Comprehensive Response to Reviewer Comments (RC1–RC3) and Editorial Decision

EGUSPHERE-2025-272 | Technical note

Technical note: Efficiency of various evaporation barriers for use in automated water samplers for subsequent water isotope analysis

Figure 1: A First experimental setup using an oven for temperature changes; B: O-rings show brittle spots due to the high temperature fluctuations

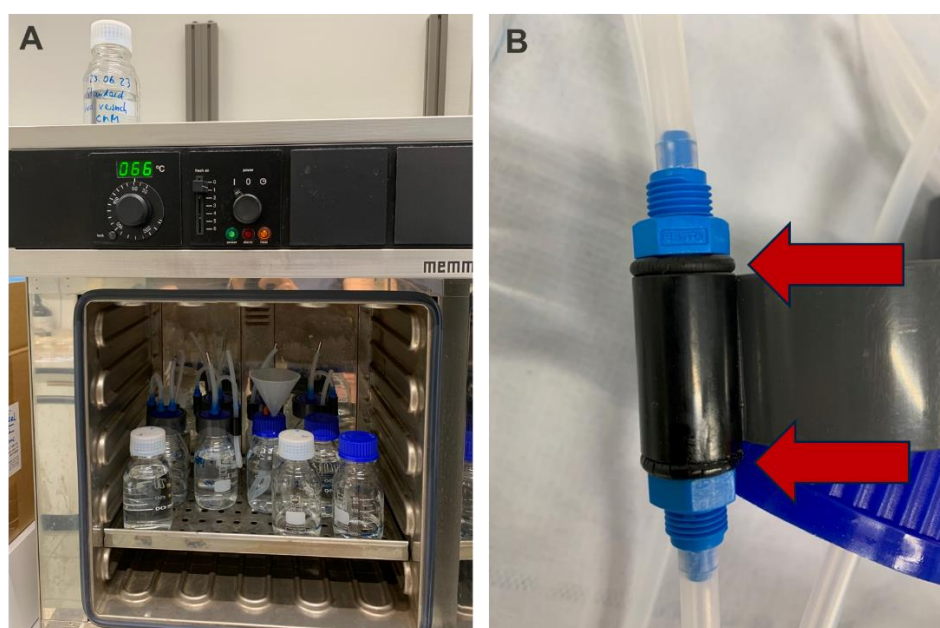
- 1) *Consider performing an additional experiment with different tube-dip-in diameters, as this was a point raised by R1*

- 2) *Additional experiments with different temperatures*

We also find this approach very interesting. However, in our experiment, the tubing diameter was not varied. The primary reason is that the connectors used were specifically designed for the selected tubing size (visible in Figure 1B) and changing them would not have been straightforward.

At the beginning of our experiment, we aimed to simulate high temperature changes to enlarge the evaporation pressure. We used a laboratory oven as Michelson et al. 2019 (HESS) used and set the temperature to 50°C. The final temperature shown by the device reached 66°C (Figure 1A).

However, after some time, we observed significant degradation of the O-rings, which are essential for maintaining the seal of the bottles. They became brittle and showed substantial damage (Figure 1B). We were concerned that this could lead to leaks, compromising the integrity of the results. For this reason, we decided to discontinue the use of the oven in subsequent experiments. All plastic components were replaced, and the experiment was restarted under ambient laboratory conditions.
